FACILITY COMPLIANCE INSPECTION REPORT
Division of Waste Management
Solid Waste Section

Date of Site Inspection: March 16, 2016 Date of Last Inspection: January 28, 2015

Dare County C&D Landfill
1603 Cub Road
Manns Harbor, 27953

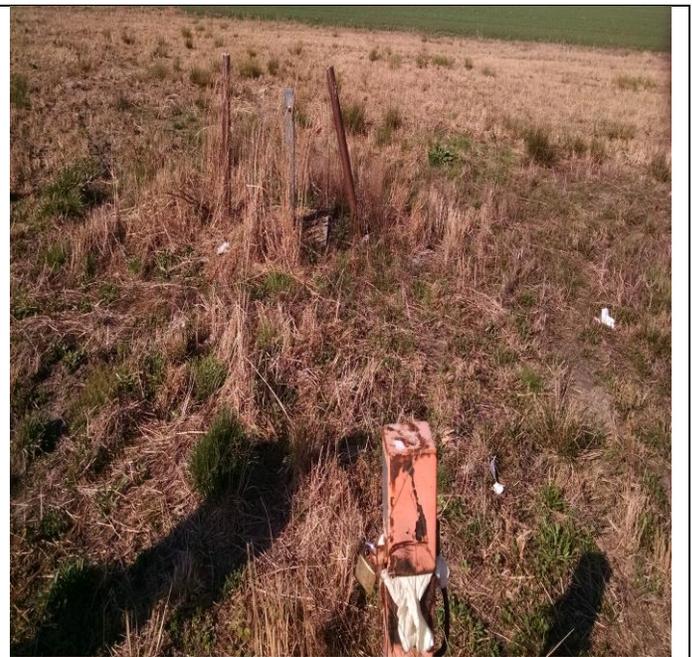
- 07 – Facility monitoring wells observed and appear to be maintained. **Monitoring Well #6 was unlocked. Be sure to lock all well heads. Environ 1 contracts the monitoring of wells. New locks have been ordered for wells.**
